BUILDING F HVAC PENETRATION  
LAYOUT SUBMITTAL 12/15/2020

BUILDING F RCP

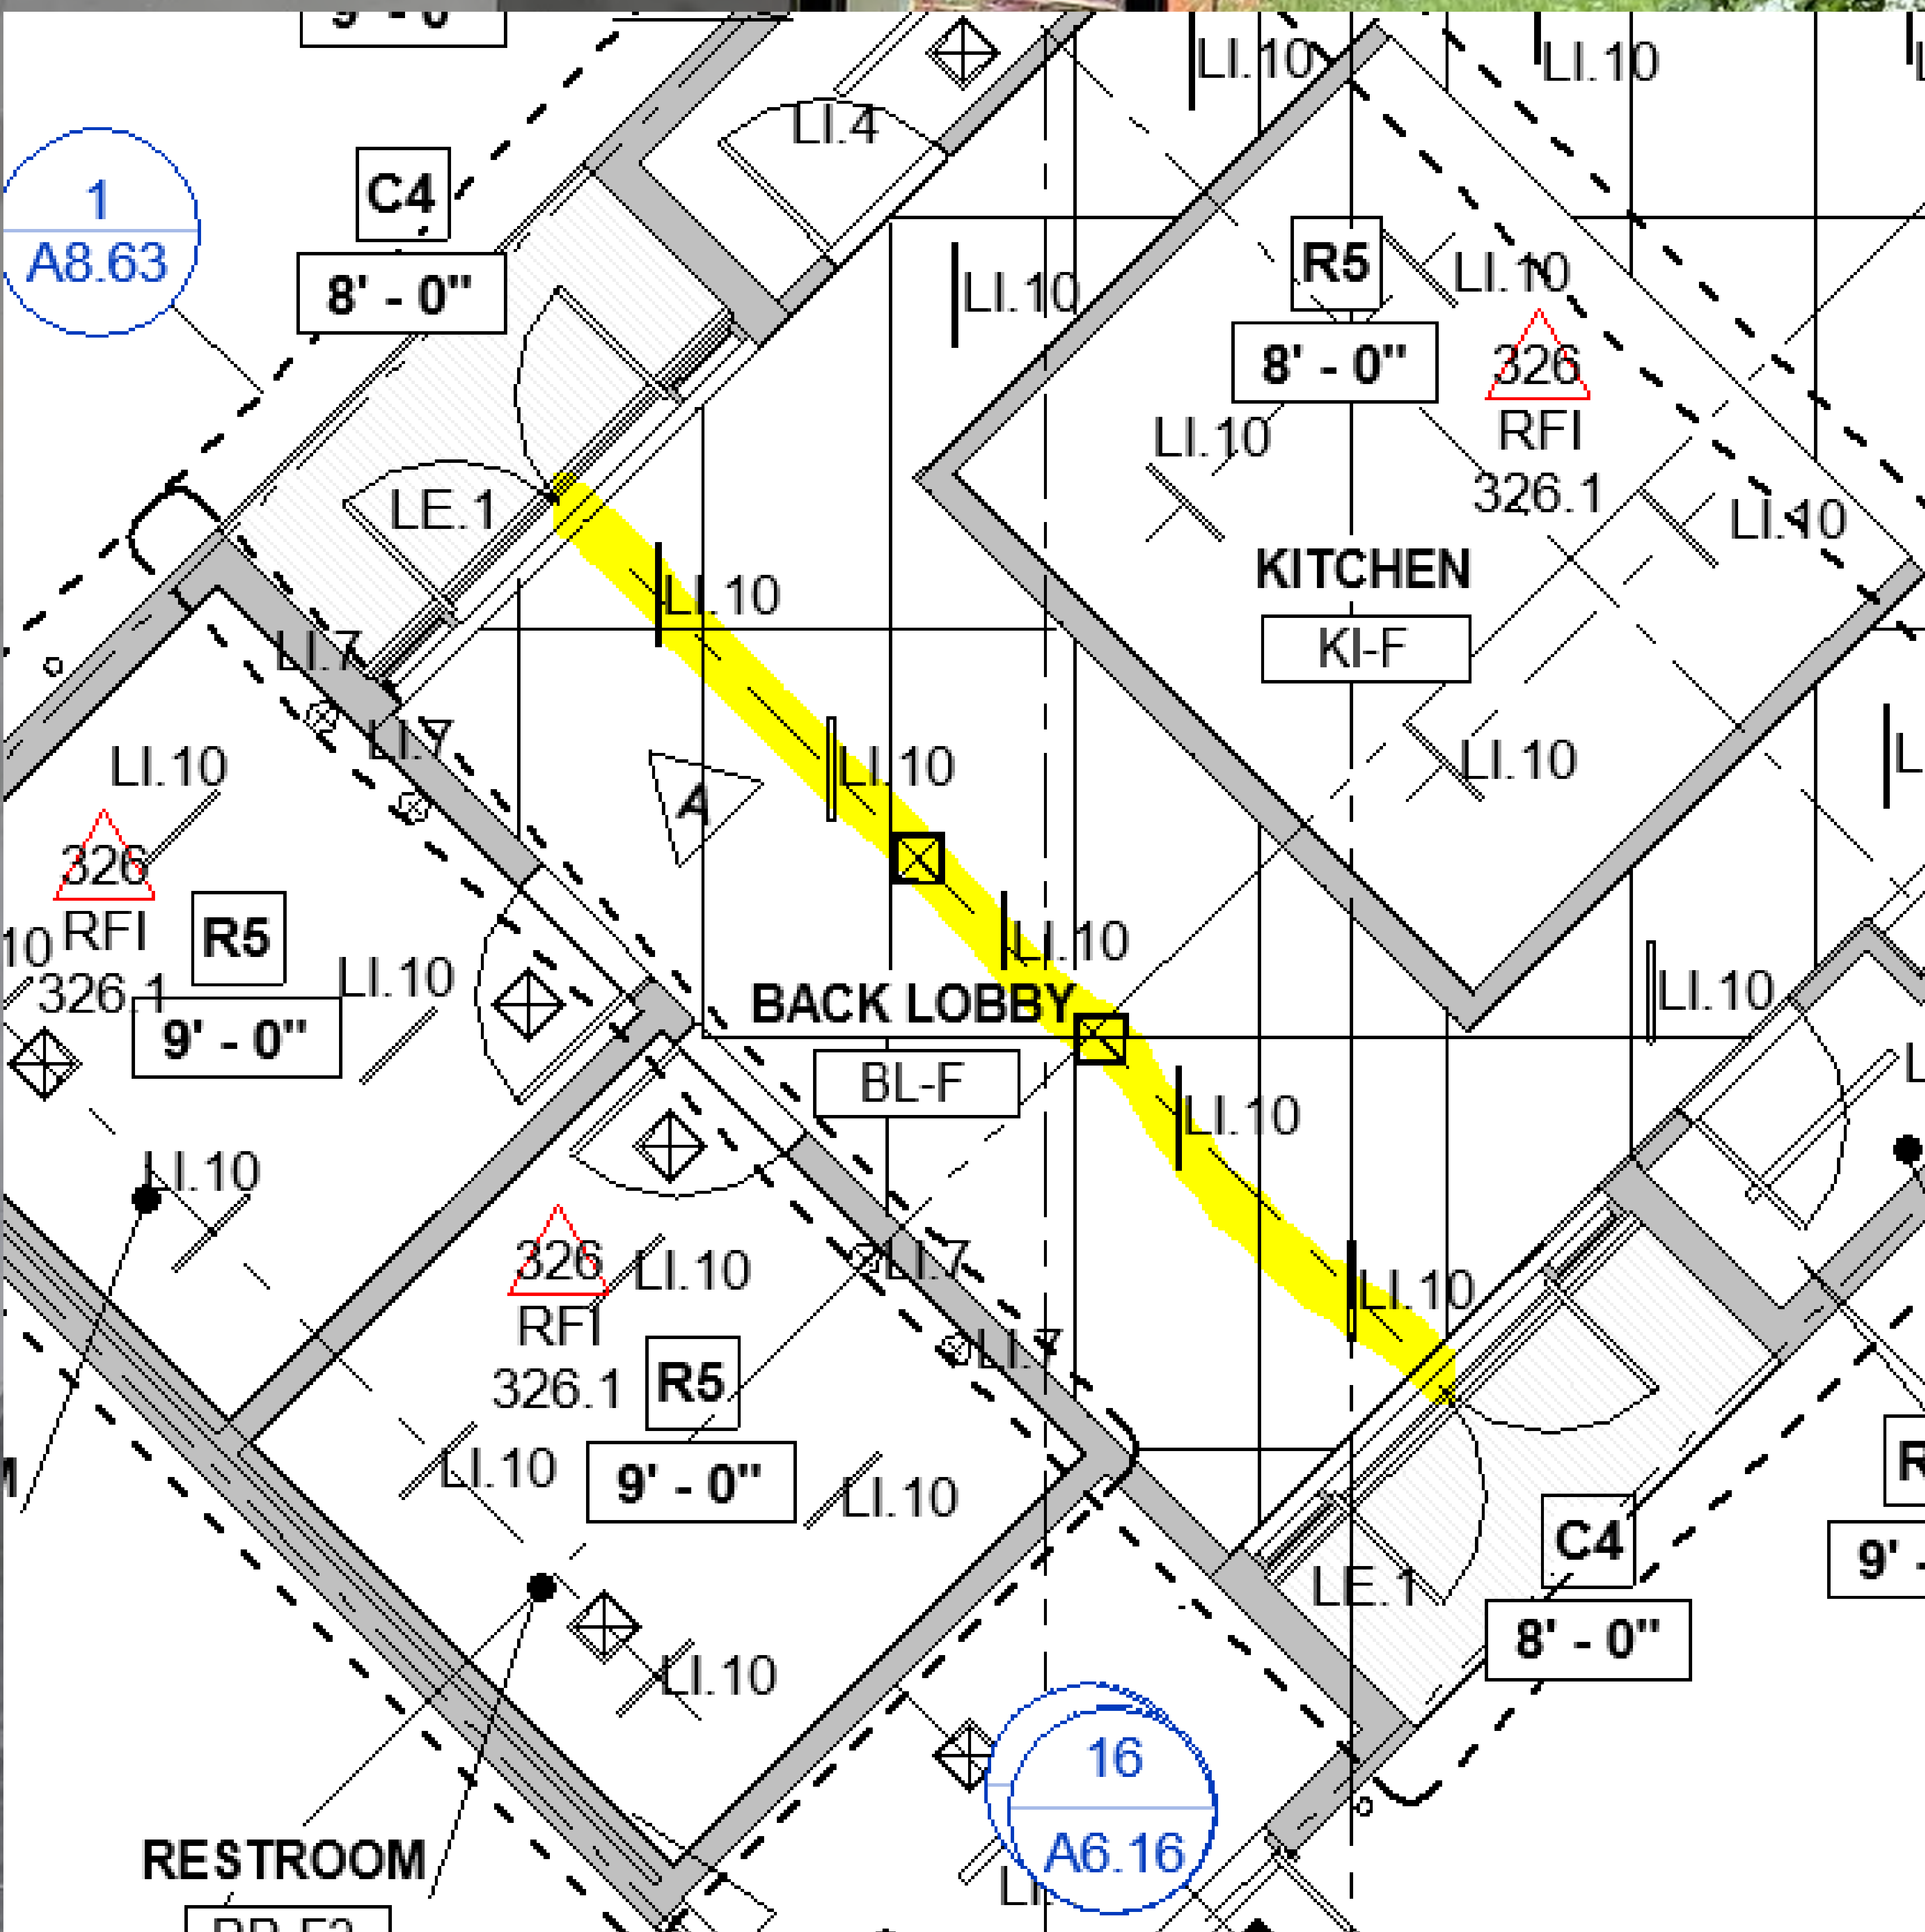
HVAC SHOULD BE  
CENTERED IN SPACE  
AND AT AN ANGLE TO  
MATCH THE LIGHTS.  
SEE RCP BELOW FOR  
REFERENCE.

LIGHTS IN BACK HALLWAY OF  
BUILDING F SHOULD BE  
CENTERED IN THE SPACE  
AND DOOR. REMOVE AND  
REPLACE
